Amendments to the Drawings:

REMARKS/ARGUMENTS

Fig. 1

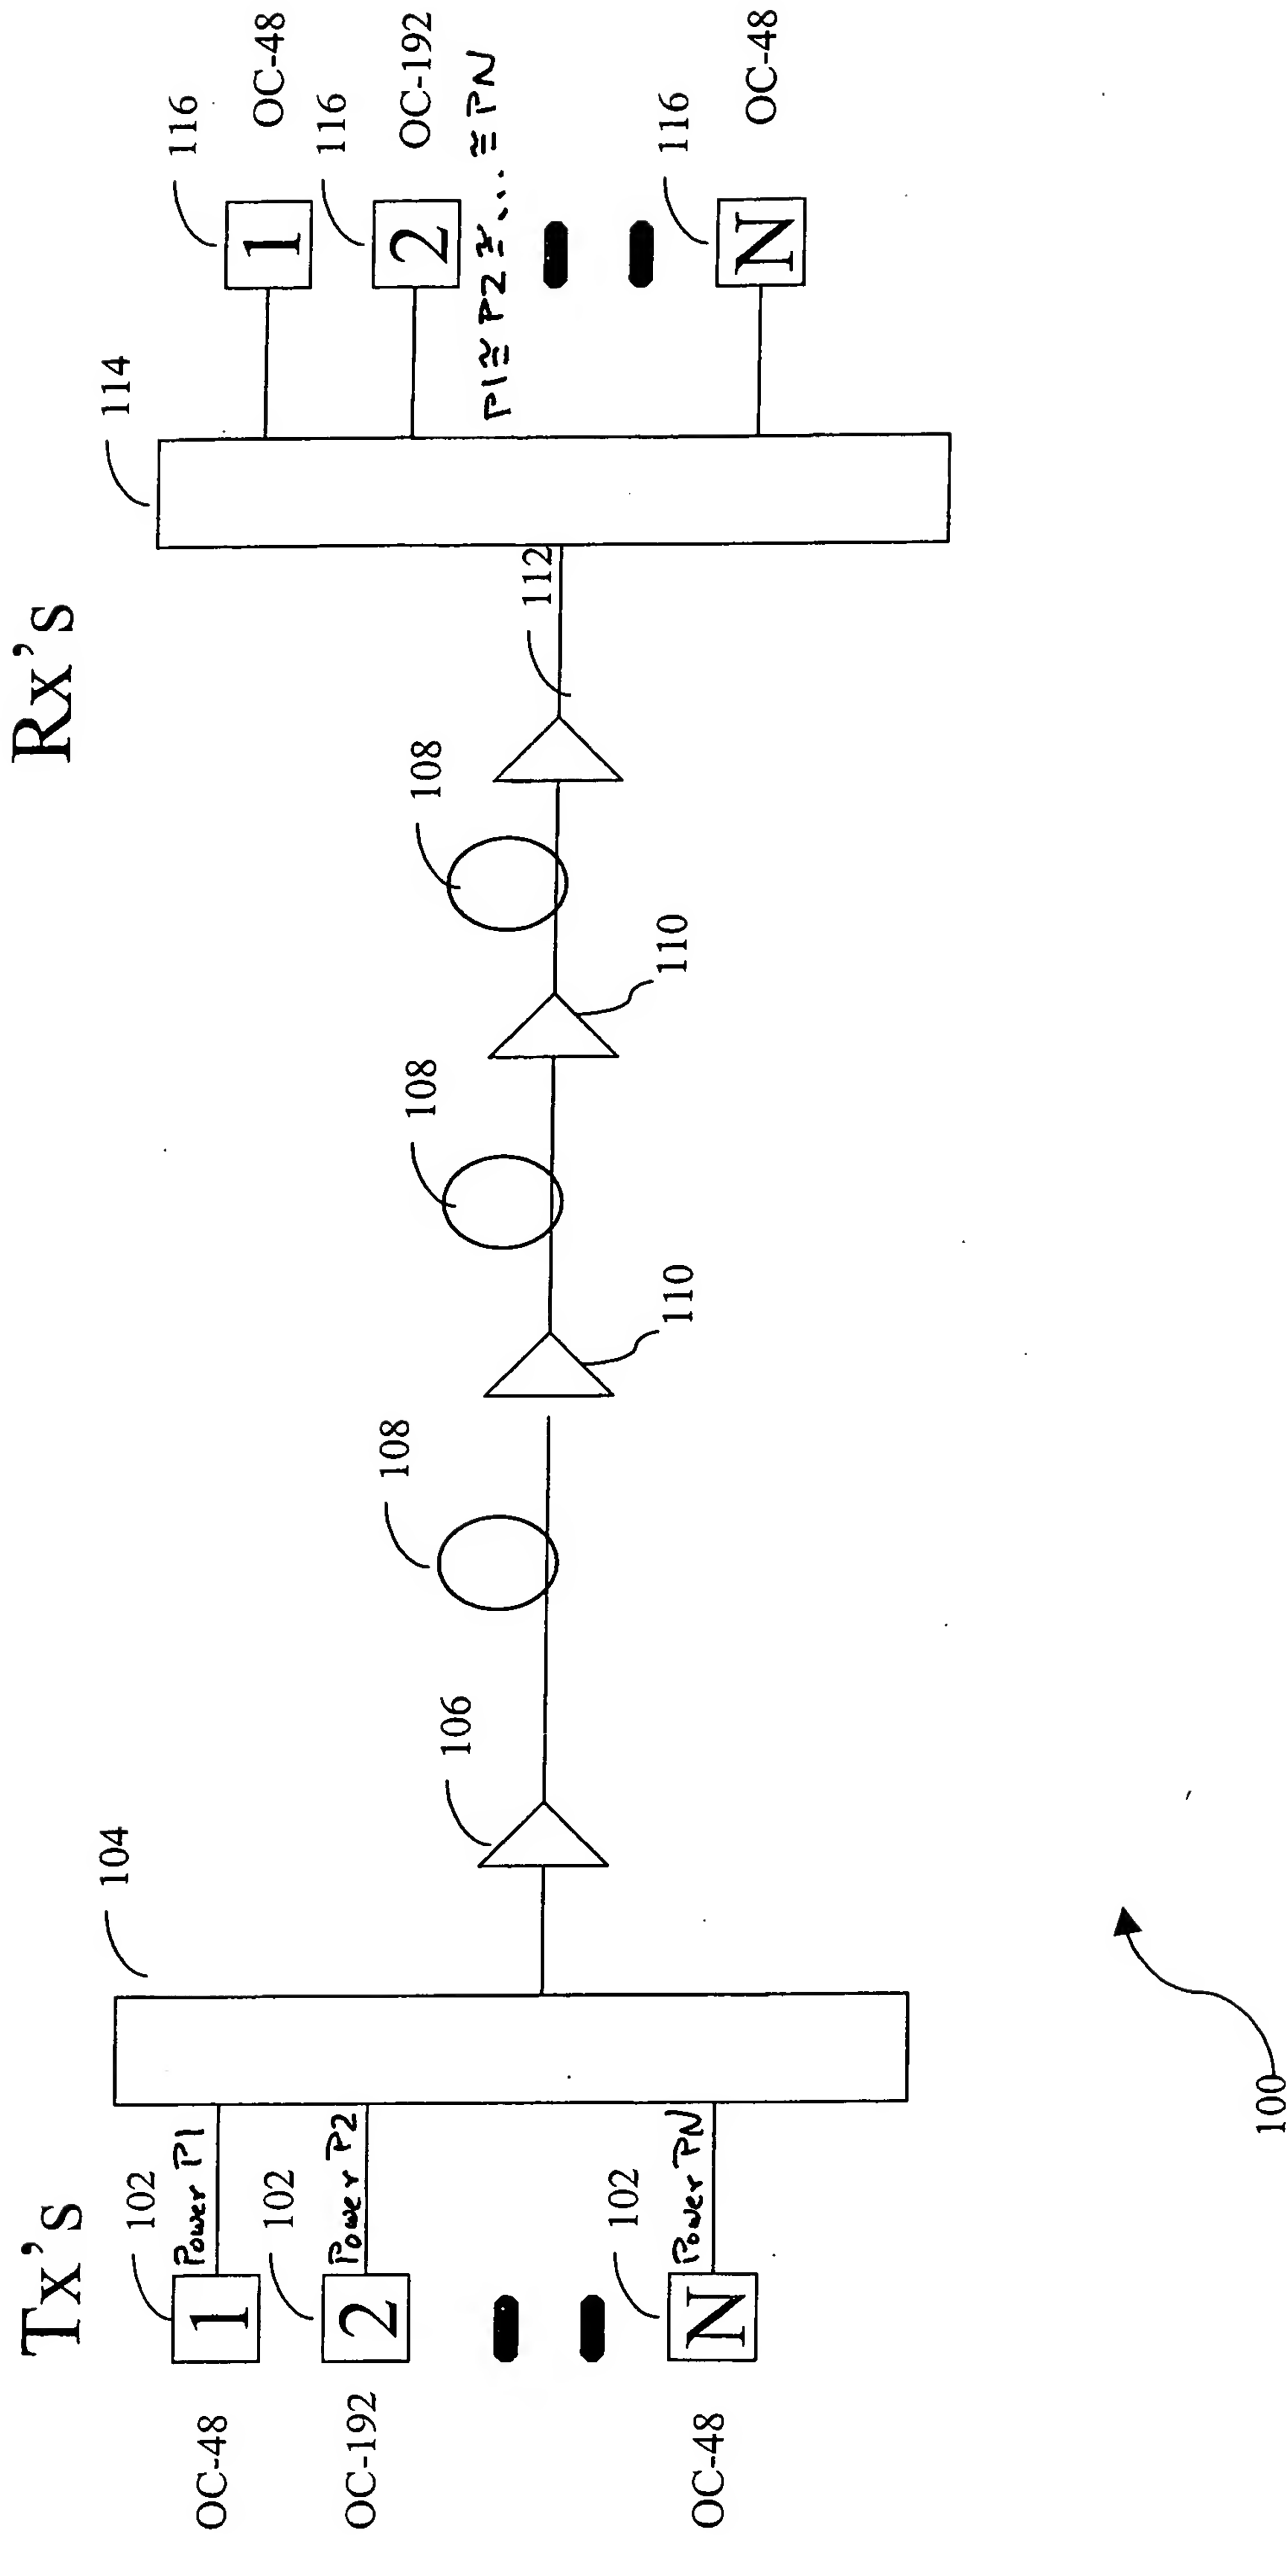
The attached five sheets of drawings replace all original sheets including Figs. 1, 2 and 3. The replacement drawings includes changes: 1) to Fig. 1 to indicate power for each of the transmitters on the left side and their general equality on the right side of the drawing; 2) to Fig. 2 to change the bottommost label of "OC-192" to "OC-48." The replacement drawings also include added Figs. 4A and 4B.

In response to the Examiner's objections to the drawings, new drawings are submitted. In Fig. 1 power was indicated for each of the transmitters and a general equality of power at the receivers, as called for in the claims. The applicants also found a mismatch in data signal rates between the transmitters and receivers in Figs. 2 and 3 and elected to correct Fig. 2. The bottommost transmitter now reads, "OC-48."
